UNITED STATES PATENT AND TRADEMARK OFFICE

APPLICATION NO.	FILING DATE	FIRST NAMED INVENTOR	ATTORNEY DOCKET NO.	CONFIRMATION NO.
10/611,978	07/03/2003	Hideo Fujiwara	239658US23X	4244
22850	7590	12/26/2007		
OBLON, SPIVAK, MCCLELLAND MAIER & NEUSTADT, P.C. 1940 DUKE STREET ALEXANDRIA, VA 22314			EXAMINER CHEN, TIANJIE	
			ART UNIT 2627	PAPER NUMBER
			NOTIFICATION DATE 12/26/2007	DELIVERY MODE ELECTRONIC

Office Action Summary

Non-Final Rejection (RCE)

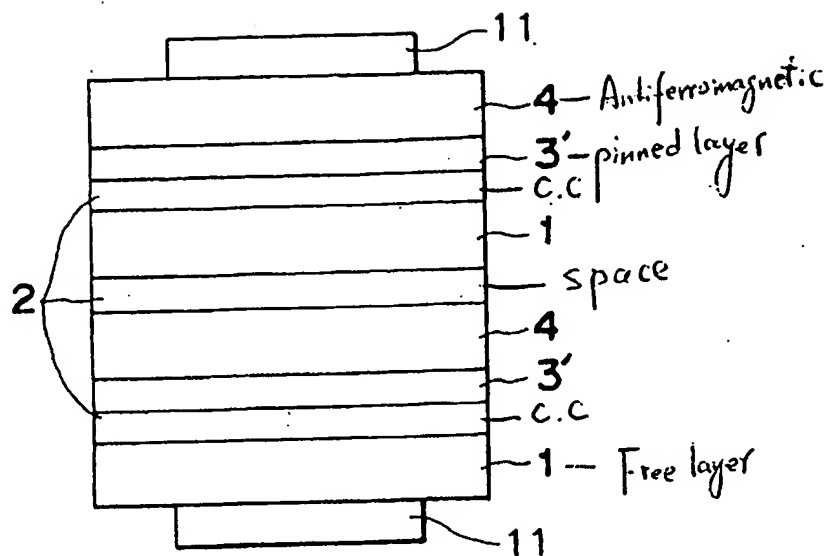
Claim 1, Sakakima et al shows a CPP spin-valve element with two electrodes 11 and 11 (Column 3, line 20) formed on an inherent substrate (See Fig. 5 attached in next page and column 5, lines 4 – 49) including: a free layer structure including at least one ferromagnetic layer; a pinned layer structure including at least one ferromagnetic layer, the free layer is magnetically softer than the pinned layer (column 4, lines 376-39); a thin non-magnetic spacer layer structure configured to separate the free layer and the pinned layer to prevent a magnetic coupling between the free and pinned layer structures, and to allow an electric current to go there through; and wherein at least two current-confining (CC) layer structures 2 including at least two parts 21 and 22 having significantly different current conductivities (Fig. 2A and 2B, column 3, lines 44-46); wherein each of the at least two CC layer structures is located on a different side of the thin non-magnetic spacer layer.

Claim 8, Sakakima et al further shows in Fig. 5 attached above that one of the CC-layer structures is located in the vicinity of the free layer structure, and another of the CC-layer structures is located in the vicinity of the pinned layer structure.
